Landscape Referral Response

Application Number:	DA2019/0087
Date:	16/08/2019
Responsible Officer:	Daniel Milliken
Land to be developed (Address):	Lot 5 DP 25713 , 8 Gladys Avenue FRENCHS FOREST NSW 2086

Amended Landscape Plan by Belmarch:

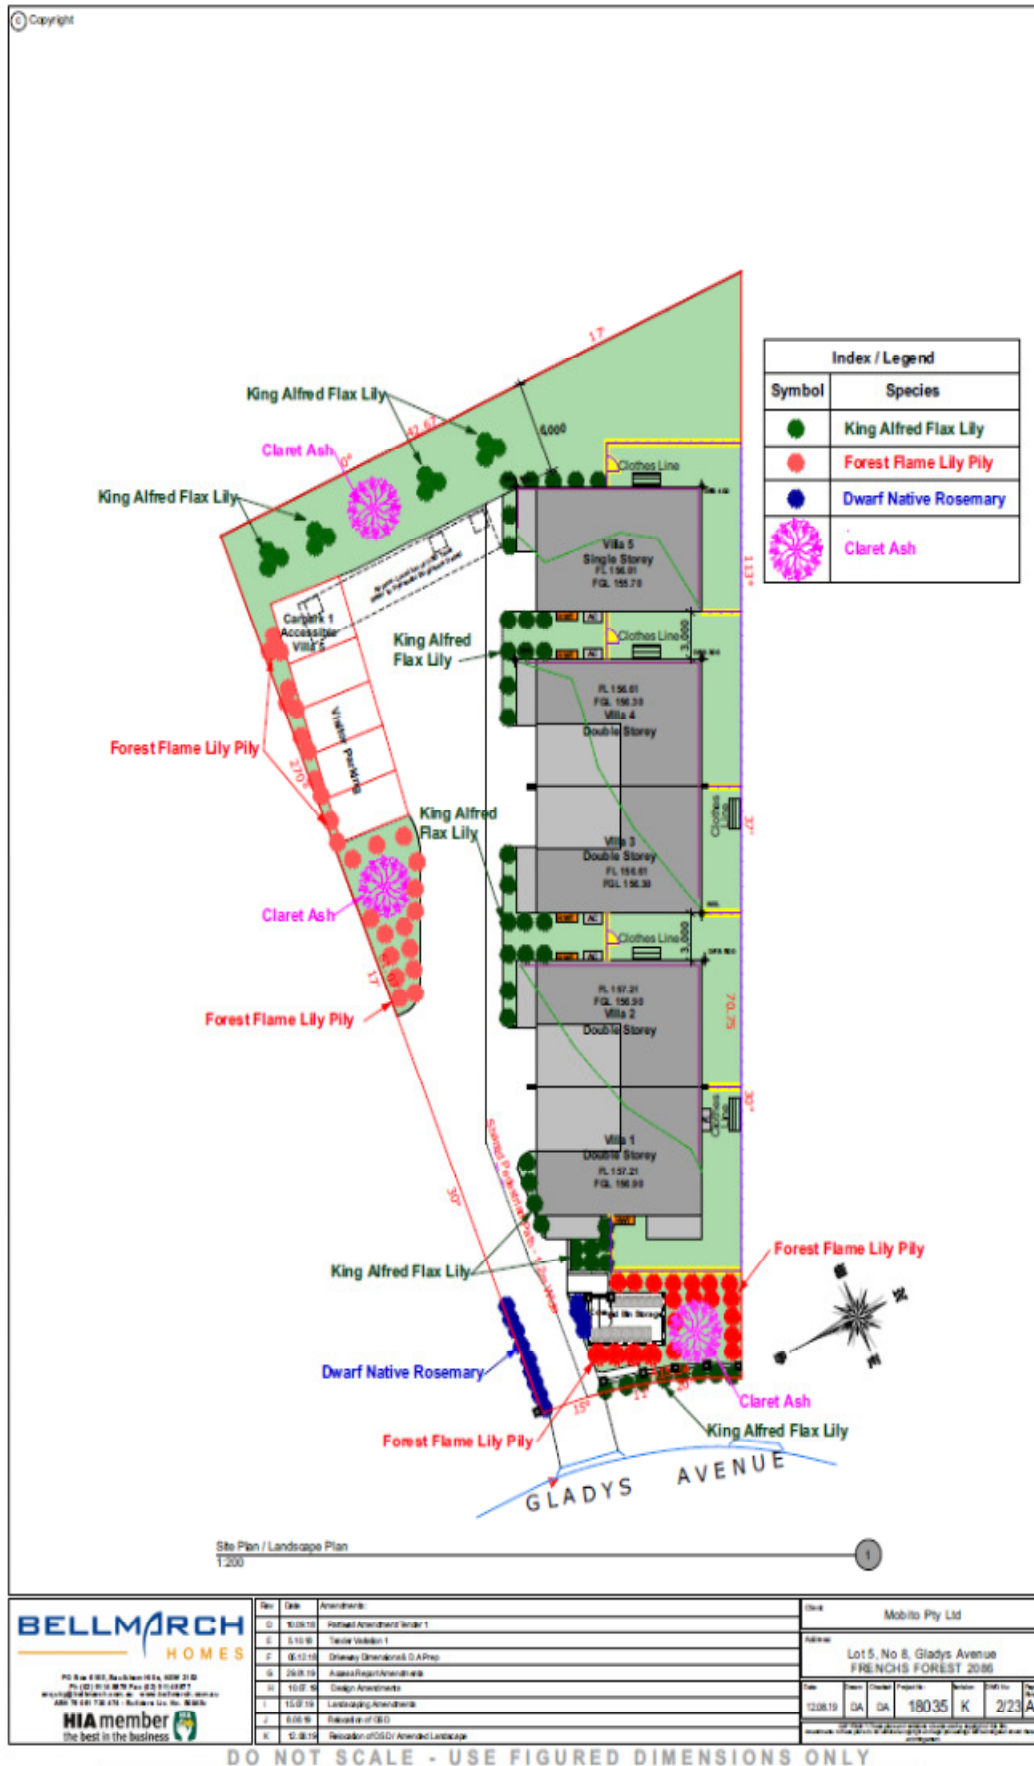
An amended landscape plan has been included in the updated drawing, however the original landscape plan also appears.

The new landscape plan, prepared by Belmarch Homes, shows the additional planting areas but the proposed planting indicated on that plan is not considered suitable. If the previous landscape plan prepared by Eco Design can be updated to reflect the new layout with additional species indicated in addition to those shown on that plan, the proposal could be considered acceptable in relation to the relevant controls.

It is recommended that the EcoDesign plan be updated and form part of stamped plans if the proposal is to be approved.
